ANN ARBOR HISTORIC DISTRICT COMMISSION

Staff Report

ADDRESS: 1533 Broadway Street, Application Number HDC21-079

APPLICATION: The applicant seeks HDC approval to construct a small addition on the rear (northwest) corner of the house, to infill a space between the house wall and new addition.

SITE PLAN

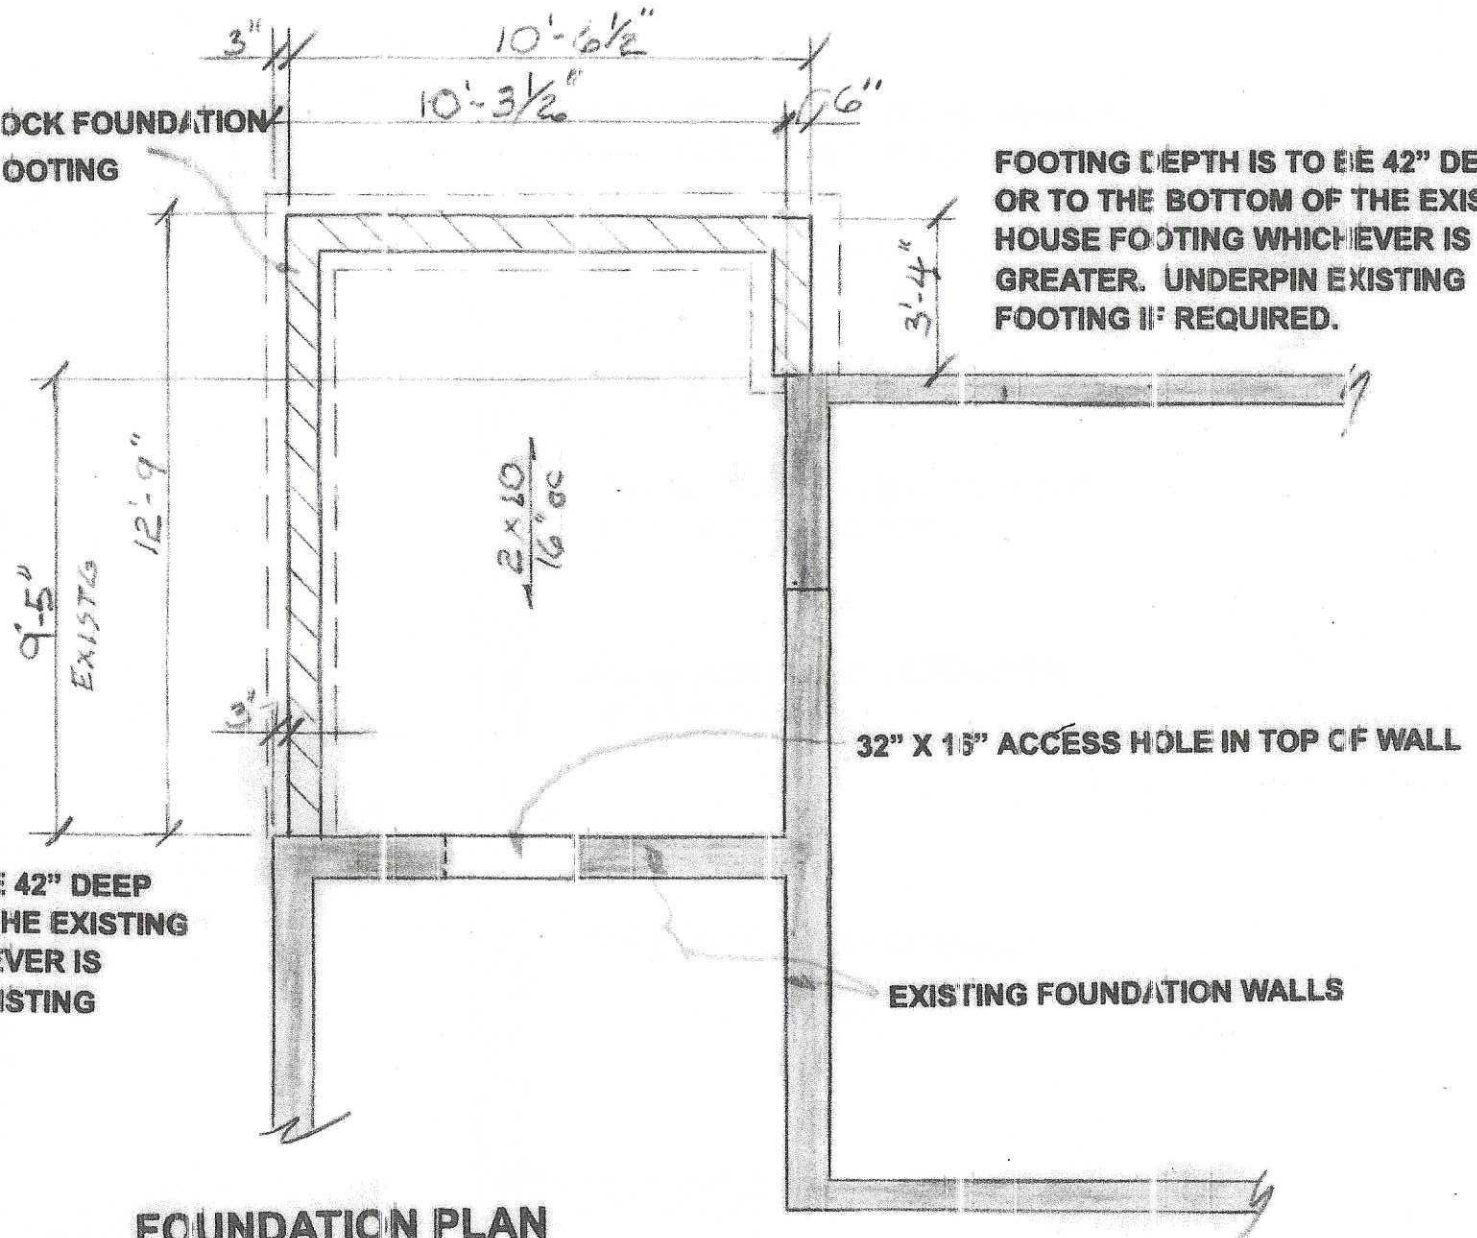
2. The new addition extends 3' 4" beyond the existing rear addition. The siding, 1"x6" wood shiplap, matches that found on the existing rear addition. An air conditioning unit would be moved a few feet beyond the new wall on the side of the house. The foundation is concrete block. A modern wood window removed from the west wall would be installed on the new addition. The opening for that modern window would be converted to an interior door. As on the current rear addition, the eave will be 16' less deep than the eave on the original house. The new west wall is inset 3" from the existing cmu corner of the house.
